**SOLICITATION AMENDMENT
MODIFICATION DE L'INVITATION**

Title - Sujet New Residence Nouvelle résidence	
Solicitation No. - N° de l'invitation EZ899-220930/A	Amendment No. - N° modif. 002
Client Reference No. - N° de référence du client	Date 2021-08-27
GETS Reference No. - N° de référence de SEAG PW-SPWY-031-9034	
File No. - N° de dossier PWY-1-44072 (031)	CCC No./N° CCC - FMS No./N° VME
Solicitation Closes - L'invitation prend fin at - à 02:00 PM Pacific Daylight Saving Time PDT on - le 2021-09-09 Heure Avancée du Pacifique HAP	
F.O.B. - F.A.B. Plant-Usine: <input type="checkbox"/> Destination: <input checked="" type="checkbox"/> Other-Autre: <input type="checkbox"/>	
Address Enquiries to: - Adresser toutes questions à: Leung, Janie	Buyer Id - Id de l'acheteur pwy031
Telephone No. - N° de téléphone (778) 919-3273 ()	FAX No. - N° de FAX () -
Destination - of Goods, Services, and Construction: Destination - des biens, services et construction: RCMP – New Residence – New Aiyansh, BC

This Amendment 002 is raised to extend the solicitation closing date and to issue Addendum #2.

Project:	RCMP Employee Housing New Aiyanish		
Project No.:	211-02781-00	Addendum No.:	M01
Contract No.:		Da

2.2 DRAWING M3.0 (no sketch or drawing attached)

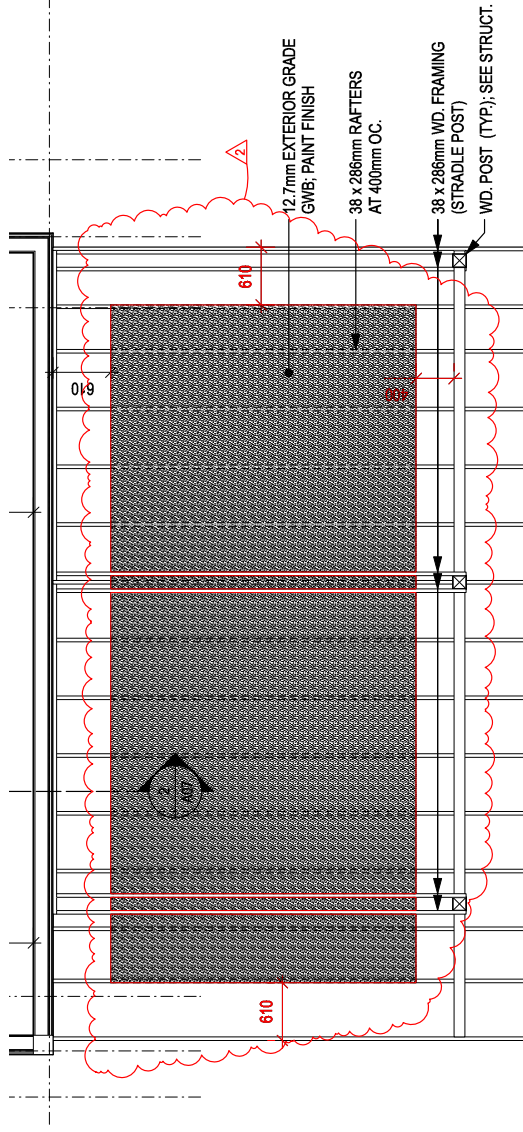
- 1 DELETE – Remove fire suppression system pipe and note “TO SPRINKLERS REFER TO DETAIL 15/M3.0” from detail 6/M3.0.
- 2 DELETE – Remove detail 15 and 16 on drawing M3.0, as the fire suppression system is no longer required.

1 PARTIAL RCP
SK-01 SCALE: 1:50

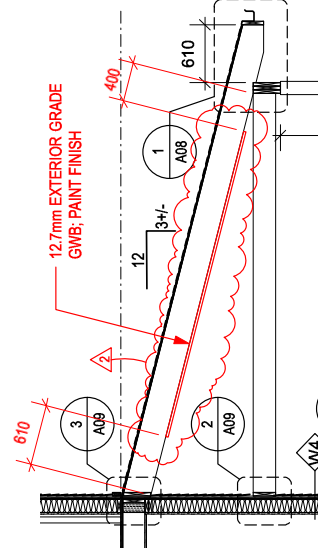
9. Clarification: Structural also shows a pair of 65x286 on each side of each post only. How is the exterior drywall to be installed that is shown on architectural?

1. Delete all notes on 1/A05 referring to wood framing at south canopy. Refer to Structural drawings for all canopy framing information. See attachment ASK-1 – this addendum.
2. Revise extents of exterior gypsum attached to underside of canopy rafters. See attachment ASK-1 – this addendum.

Response: The exterior gypsum board is to be fastened to the underside of the roof joists. See comments for Architectural Drawing A05 and attached SK-01.
